Puget Sound Clean Air Agency Written Warning

Written Warning No 2-006631

Valid Results, Inc. (VR) issues this response to the written warning issued by the Puget Sound Clean Air Agency (PSCAA), Written Warning No. 2-006631, to the Ash Grove Cement Company, concerning the NESHAP Dioxins/Furans Compliance Testing, which occurred on May 29-30, 2002. We would like to clarify several points addressed in the warning letter.

Re: Ash Grove Cement Company
May 29-30, 2002 Dioxin Furan Performance Test
and Coal Mill Testing: Written Warning Nos. 2-006631 and 2-006632

Mean Recoveries of Sampling Standards (N=10)
Project ID: Ash Grove Cement - Seattle
P2131

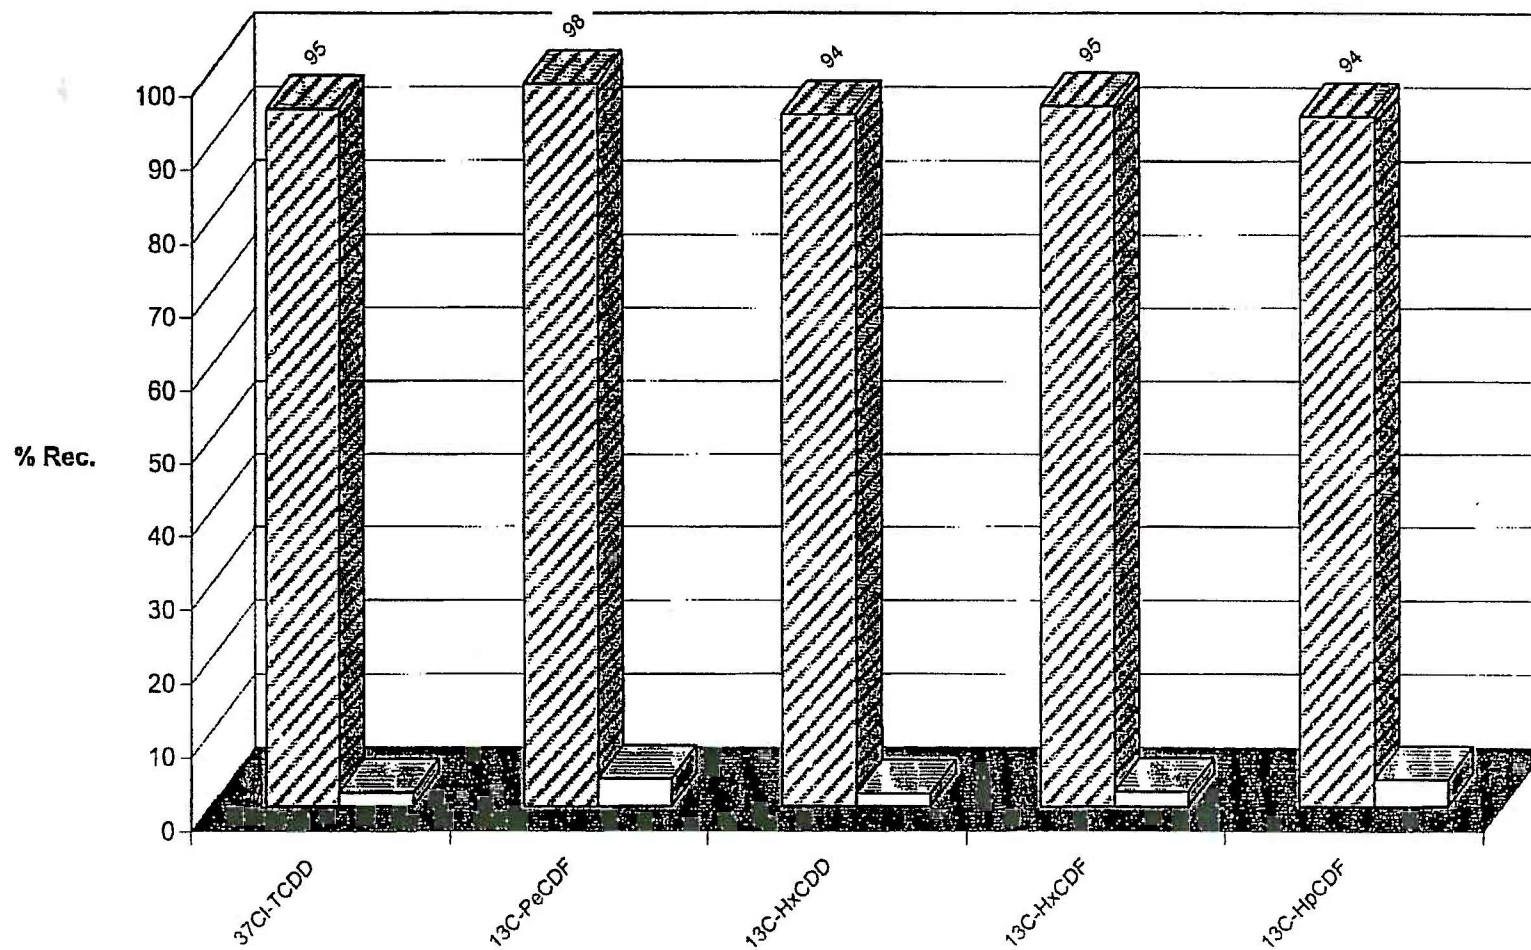
4.1.3.5 Monitor temperature of the condenser and XAD trap and keep it below 20°C during the test. We observed no thermocouple to monitor temperature on either the condenser or the XAD.

The temperature of the condenser and XAD-2 resin trap were maintained below 68 degrees F, as demonstrated by the excellent surrogate recovery percentages. The five surrogate standards recoveries were from 94 to 98 percent. These were well above the minimum 70 percent recoveries, which would indicate problems with the XAD-2 resin. The laboratory recovery results are attached below.
